# MEMORANDUM

**SUBJECT: 470-06-056 Issues Only Hearing for 700 East 300 South**

## **Description of Project:**

1898 Sanborn

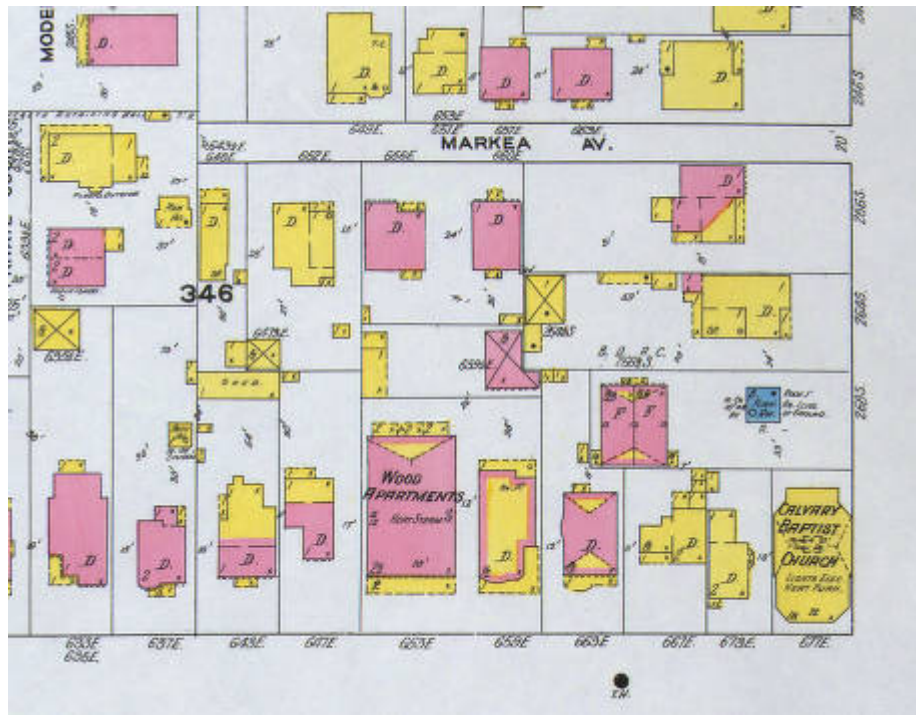
**Discussion:** The ordinance and design guidelines require preservation of the district's street plan. Originally Markea Avenue was a private alley that developed into a mid-block street sometime between

1898 and 1911. Please see Sanborn maps that follow. Even as an alleyway, there were already houses oriented towards this street. In keeping with the original development of the area and the initial plan submitted the applicant, staff recommends that there be no on-street parking on Markea Avenue. All parking should be interior.

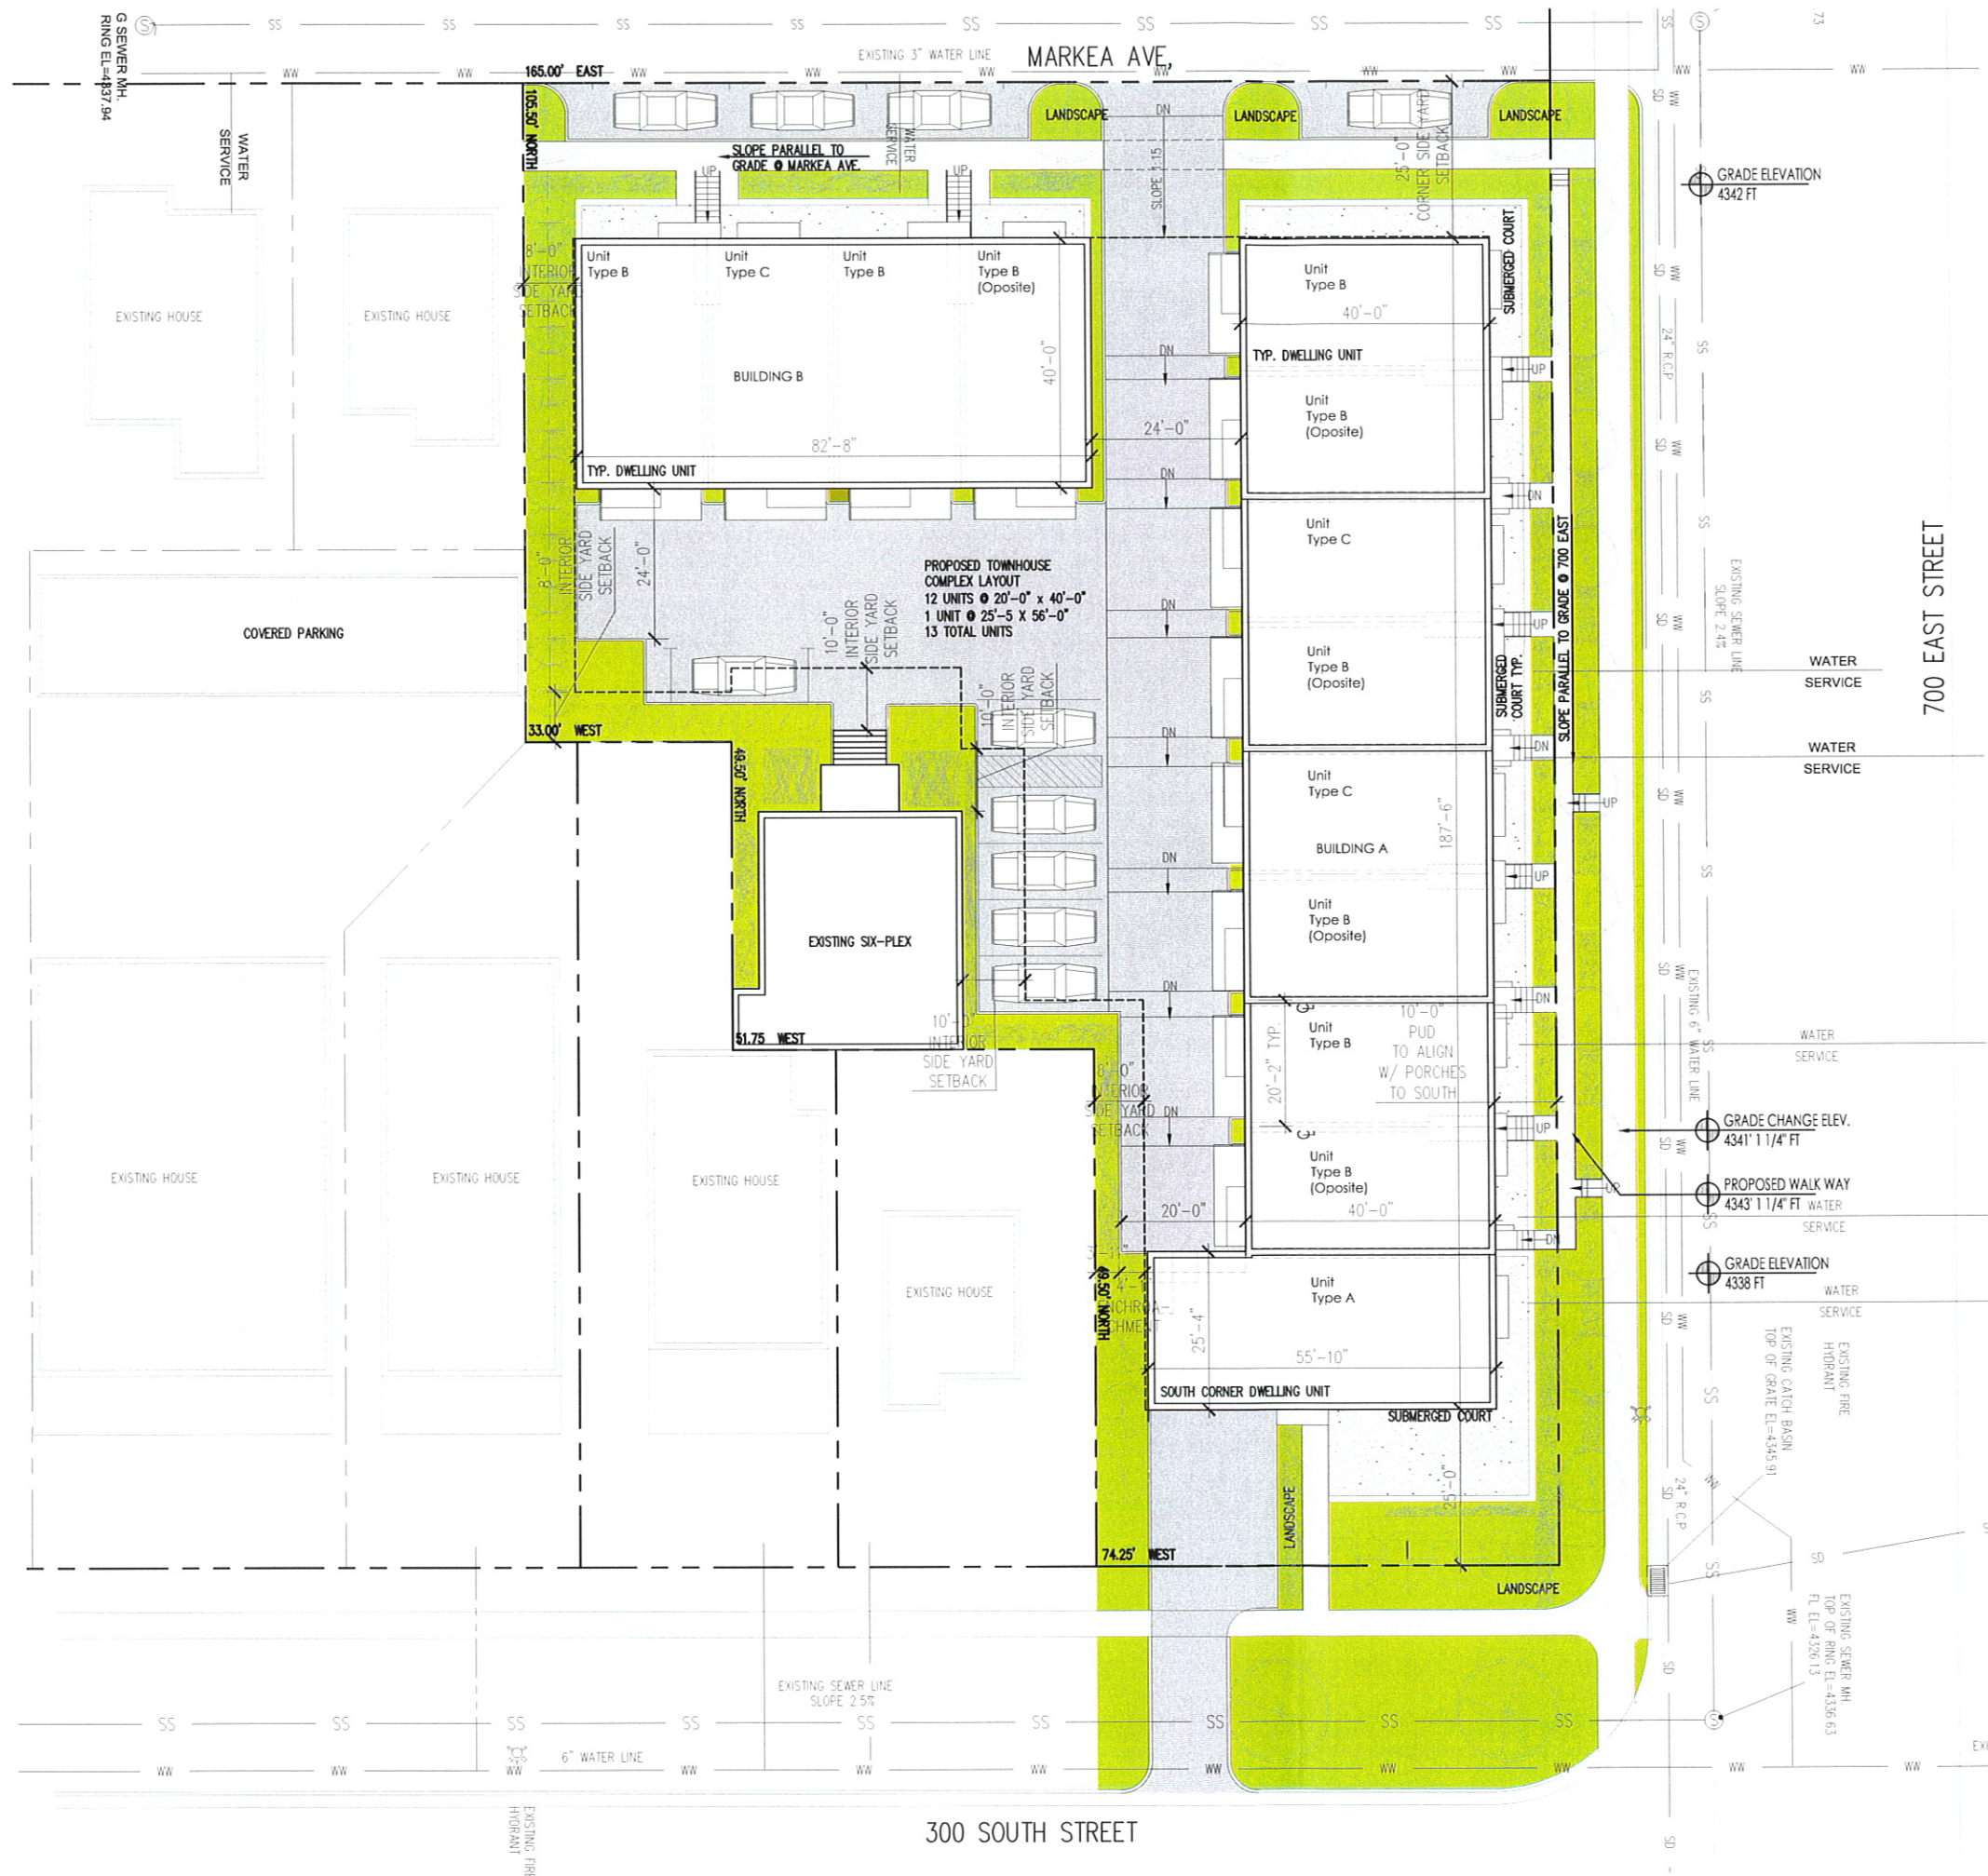
Staff recommends extending the unit at the corner of 300 South and 700 East so that there is enough room for access to a two bay garage from the interior, thereby removing the garage that currently faces 300 South. Staff does not believe that this alteration would significantly change the original site plan already conceptually approved by the HLC.

The submerged court that fronts the new structures and the walkway that parallels 700 East is inappropriate for the district. Staff recommends that the size of the court be decreased, especially at the corners. The walkway for each unit should travel from the main entrance directly to the sidewalk, as seen elsewhere in the district.

Site Elevations 32'  
 7th East Townhouses  
 Everest Builders  
 Prescott Muir Architects

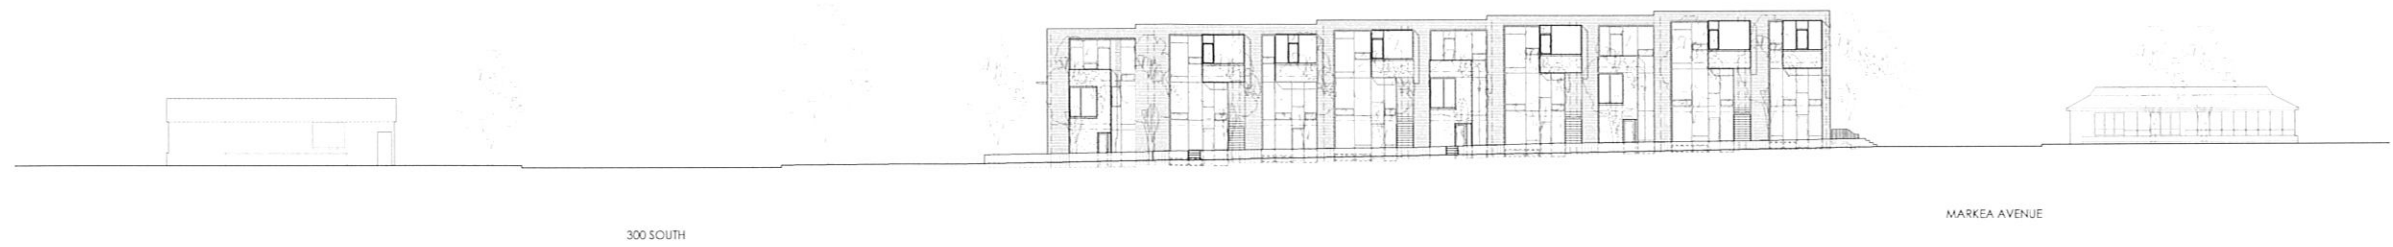
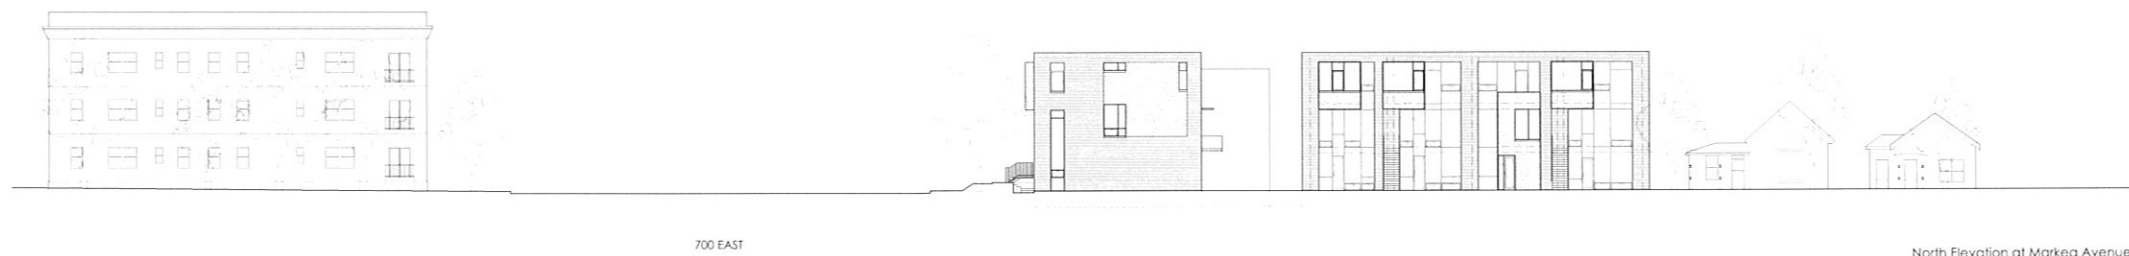
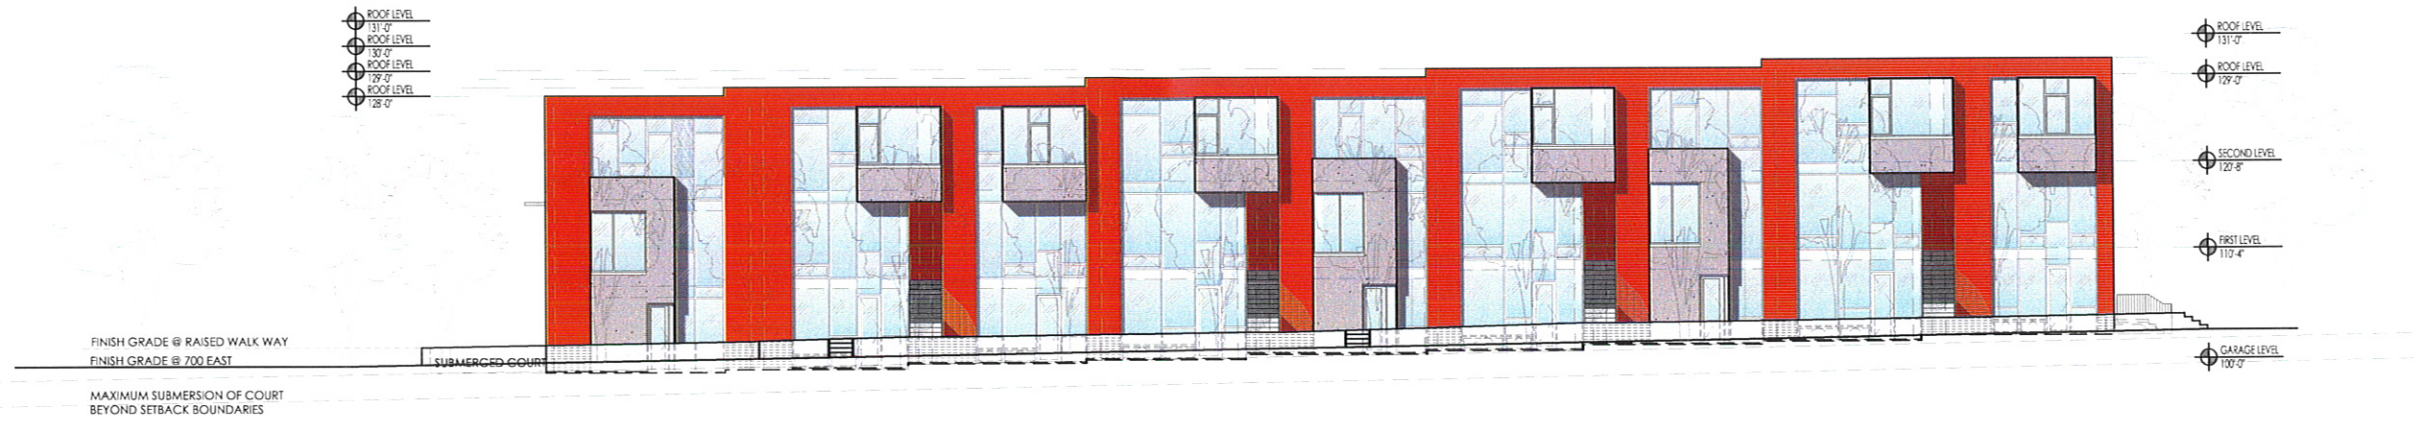
**Discussion:** The principle facades of the current design are mainly glass with off-center balconies. Staff recommends more symmetry to each bay and attention to the rhythm of solids to voids in nearby historic structures. The main entrance is currently not well defined, as required by ordinance. There should be a clear delineation of the foundation line and cornice. At this time, there is no information about materials.
